Cosumnes River Bridge Replacement Project

Sacramento County
03-Sac-99-PM: 7.1/9.4
EA: 0F280
EFIS: 0312000069

Initial Study with Negative Declaration/Section 4(f) De Minimis Determination

May 2019

Figure 1. Project Location Map – Cosumnes River Bridge Replacement Project

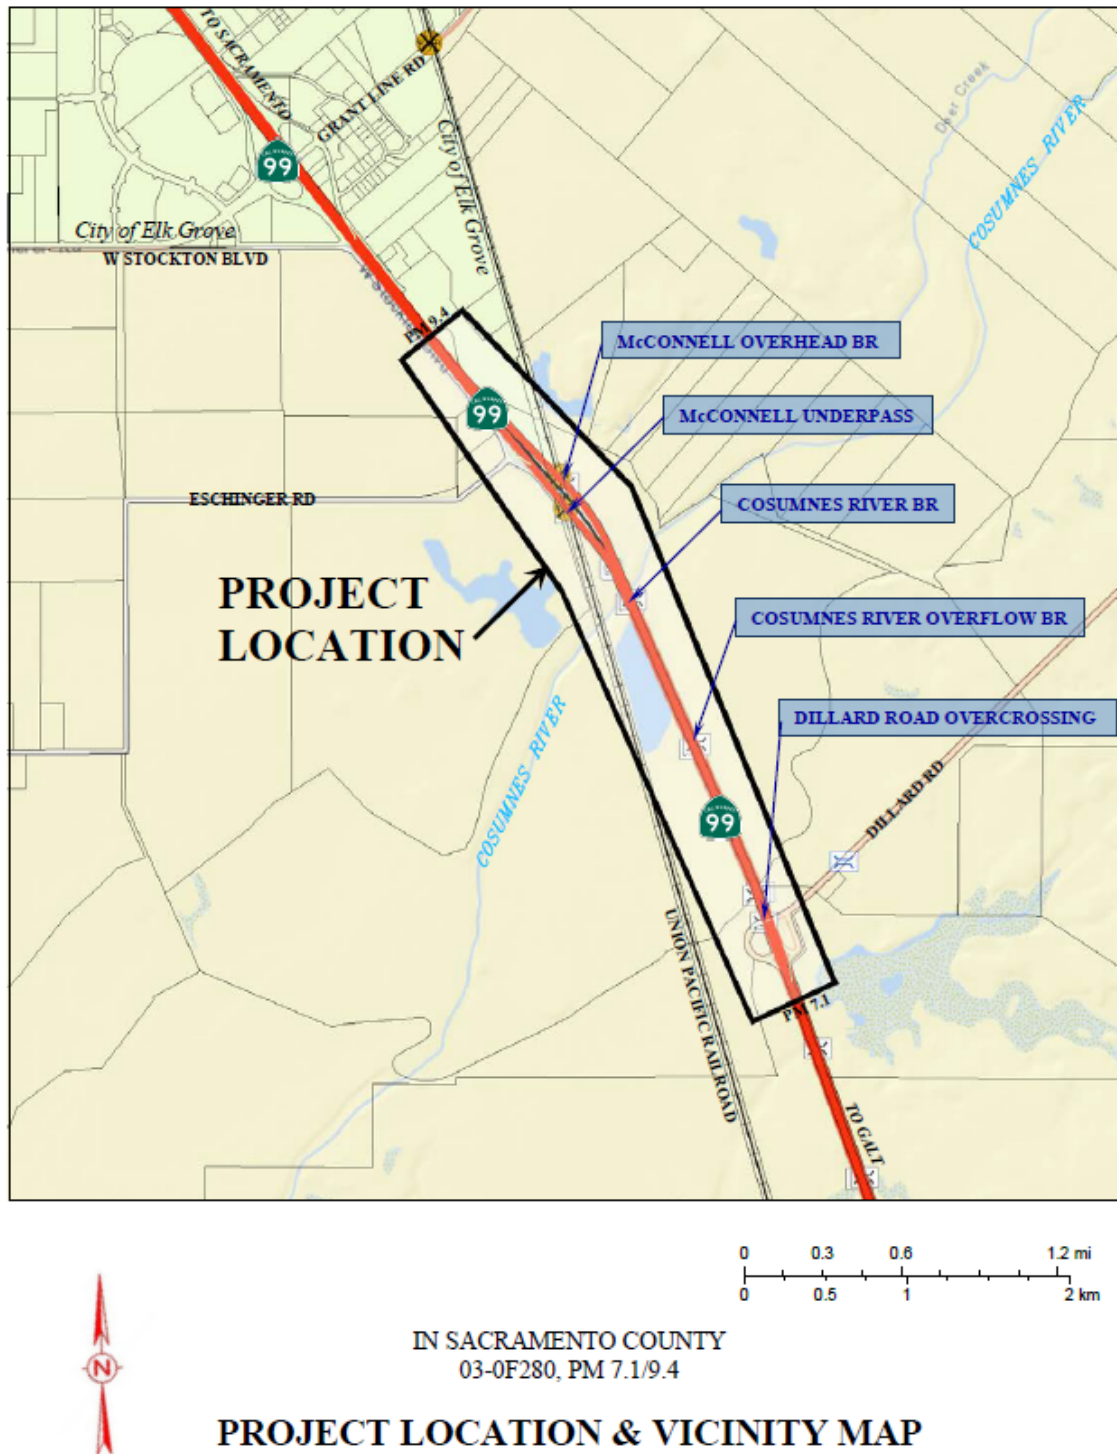
| 30 | <ul style="list-style-type: none"> Figure 2 is difficult for reader to orient where each map page is on the Project. Provide a grid index/over view map showing where each detailed map occurs throughout the Project. |

Figure 1 is an overview map of the project, with key project features identified. The individual ESL maps show the project in segments from the southern boundary at PM 7.1 to the northern boundary at PM 9.4. Nevertheless, Figure 1 has been revised to include a grid index/overlay and the Figure 2 ESL maps have been labeled accordingly. See Appendix B.

ENVIRONMENTAL STUDY LIMIT
SCALE: 1" = 50'

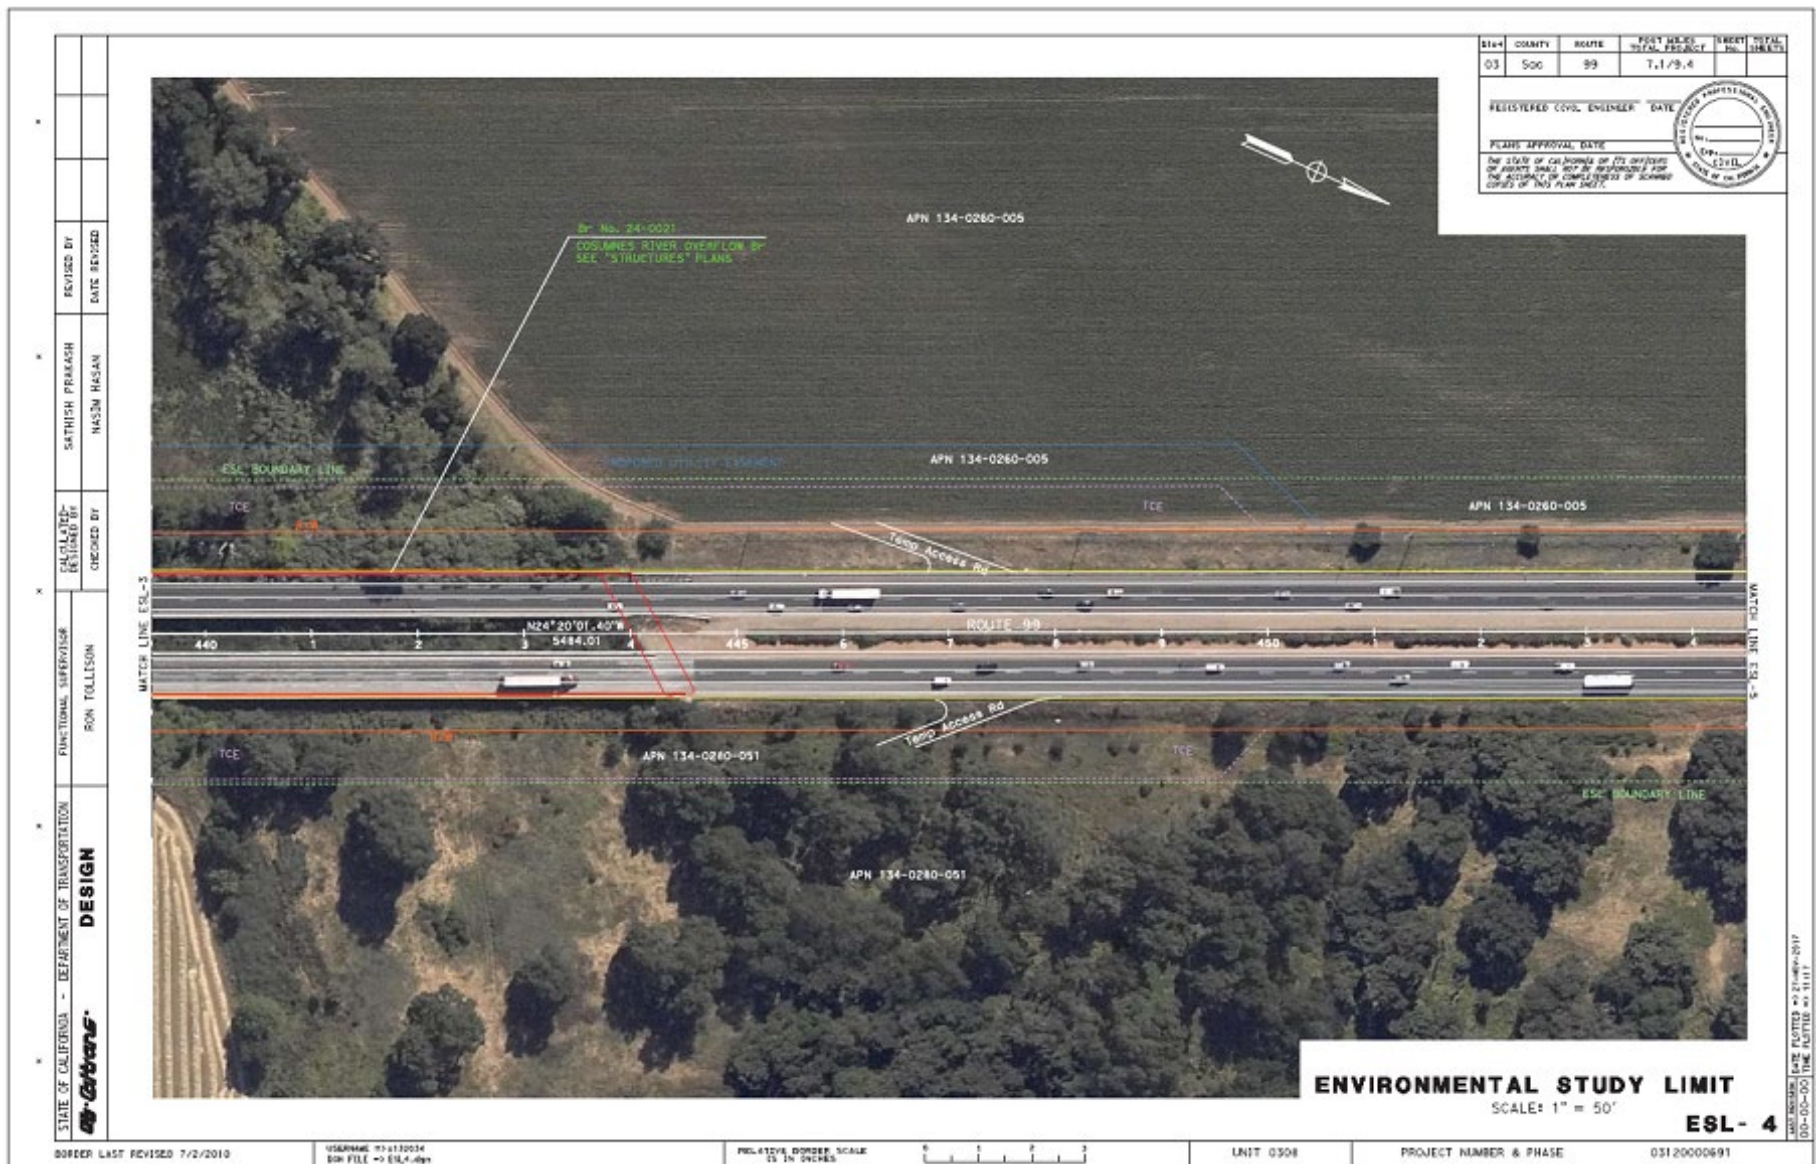
| 28 | <ul style="list-style-type: none"> It is unclear if every supporting technical study utilized the same study area delineated as the "ESL Boundary Line" on Figure 2. Please clarify. |
| 29 | <ul style="list-style-type: none"> It is unclear why there are two different "ESL Boundary Line" on Figure 2, please explain. |

All technical studies utilized, at a minimum, the ESL boundary line shown on Figure 2. Certain components of the technical studies (e.g., nesting bird surveys) utilized a greater area due to the protocol requirements of the surveys.

Figure 2 identifies the ESL boundary as both the Wood Rodgers ESL Boundary Line (green dashed line) and Additional Caltrans Work ESL Boundary Line (yellow dashed). These lines are not in conflict and comprise the ESL boundary.
